PROPOSED CHANGE: Secondary Suites

CHANGE NUMBER: BCBC2018-R201-SS

CODE REFERENCE: British Columbia Building Code 2018 - Part 9 of Division A and Part 9 of Division B

Figure A-1.1.1.1.(6)
Application of Alternative Compliance Methods in Table 1.1.1.1.(6)

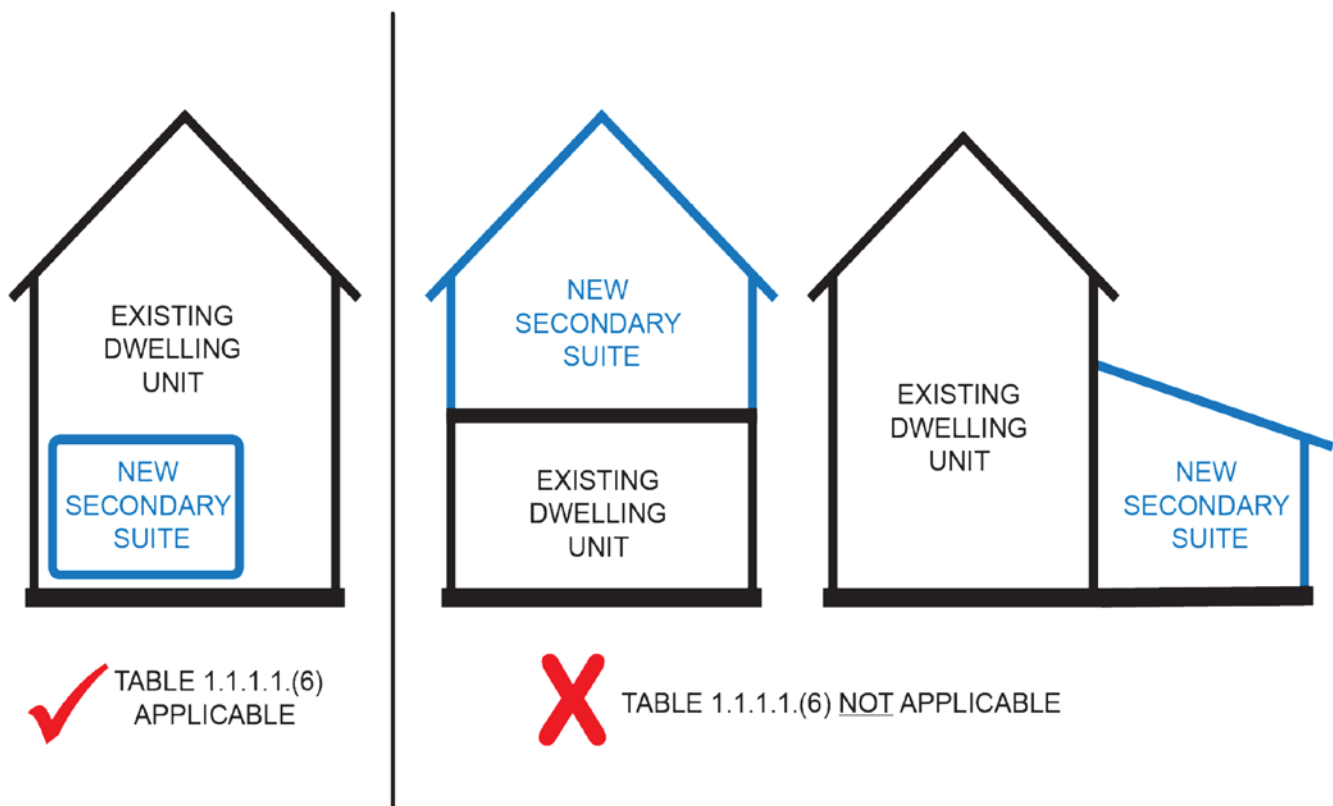
A-1.1.1.1.(6) Alternate Compliance Methods for Alterations to Existing Buildings to Add a Secondary Suite.

The requirements in Division B for the construction of secondary suites was written primarily for new construction and provides for a performance level that is higher than what may exist in existing buildings. To apply present Code provisions to existing buildings, as for heritage buildings is in many cases impractical. The Table of Alternate Compliance Methods for Alterations to Existing Buildings to Add a Secondary Suite was developed to provide alternate methods, when dealing with existing construction, without compromising the objectives of the Code. Table 1.1.1.1.(6) may be considered when assessing an existing additional dwelling unit located in a single family dwelling building (house), however is not intended to be applied as a retroactive code to these existing units, nor be applied to buildings of new construction where there are no existing assemblies to act as practical barriers to compliance with Division B of this Code. Figure A-1.1.1.1.(6) illustrates the application of Table 1.1.1.1.(6) to existing buildings.

Figure A-1.4.1.2.(1)-C

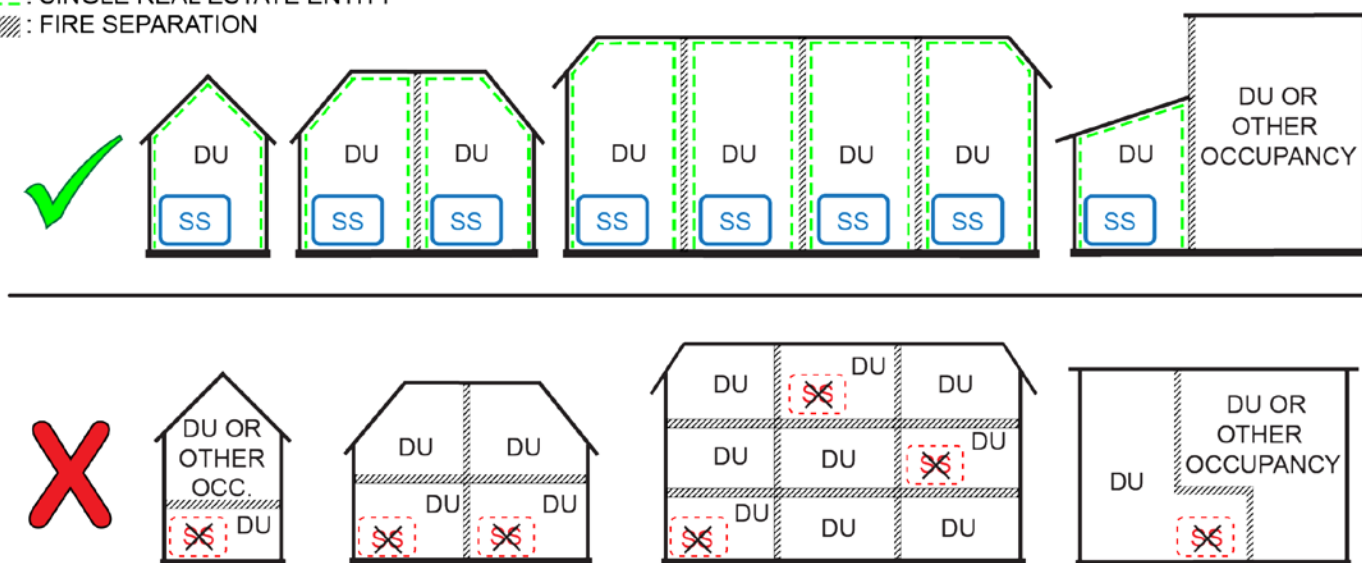
It is proposed to discontinue the prescribed floor space amounts and percentage distribution. Floor space amounts and distribution for secondary suites do not relate to a Code objective and it cannot be assumed that the owner occupies one of the dwelling units, nor that the occupant of the dwelling unit has any control over the secondary suite or its occupants. The *Local Government Act* provides authority to local governments to regulate the use of land and buildings as well as the density of the use of land and buildings, which includes establishing limitations on floor space and the number of units permitted on a lot. Overlapping jurisdiction create confusion.

Requirements for secondary suites to include a greater occupant load have been revised to reduce the probability that a person may be exposed to an unacceptable risk. Consideration of openable windows in lieu of a second and separate means of egress is proposed and coordinates with egress from dwelling units in Subsection 9.9.9.

As an alternative to floor area limits as a mechanism to limit occupants, it is proposed to instead provide acceptable solutions such as protection from fire on emergency egress facilities that allow for a reasonable number of occupants.

Figure A-9.5.3.1.
Ceiling Heights and Clear Heights

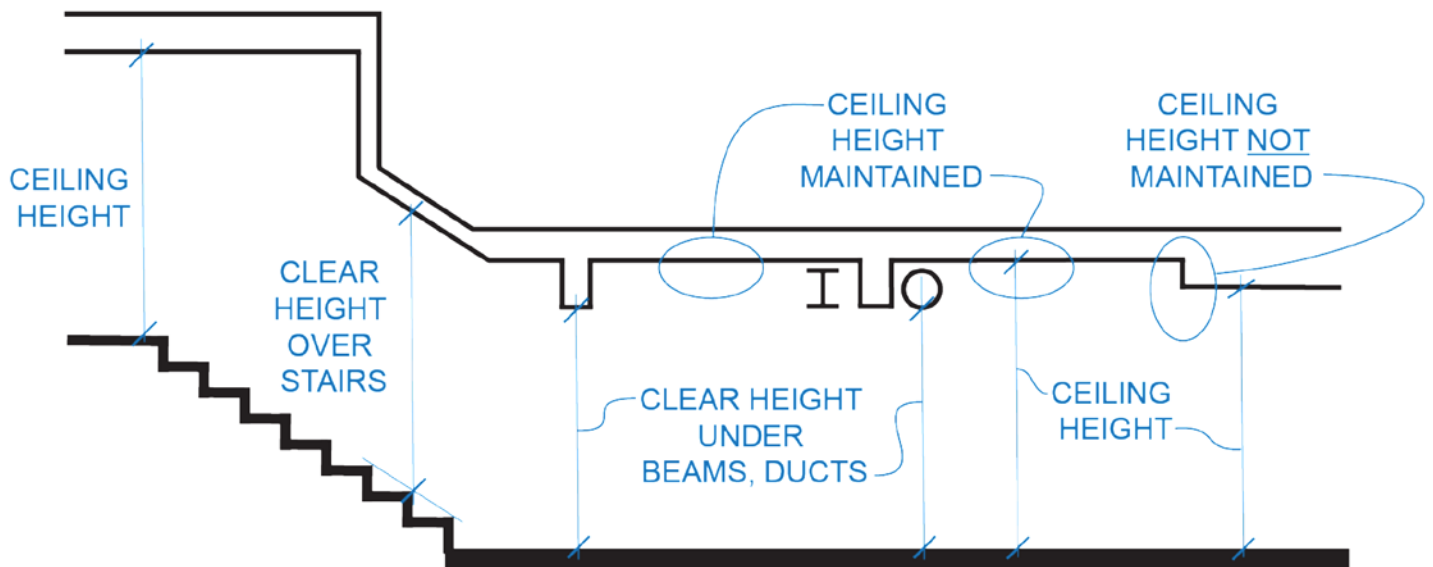
It is proposed that buildings of new construction and additions to existing buildings provide the same ceiling and clear heights as required for all other residential occupancies. The BCBC contains a relaxation for ceiling and clear heights, and it is proposed that such a relaxation be permitted for alterations to existing buildings only where raising the building to provide the required ceiling and clear heights would be cost-prohibitive. Article 9.5.3.1. will apply to secondary suites in buildings of new construction and those built as additions to existing buildings.
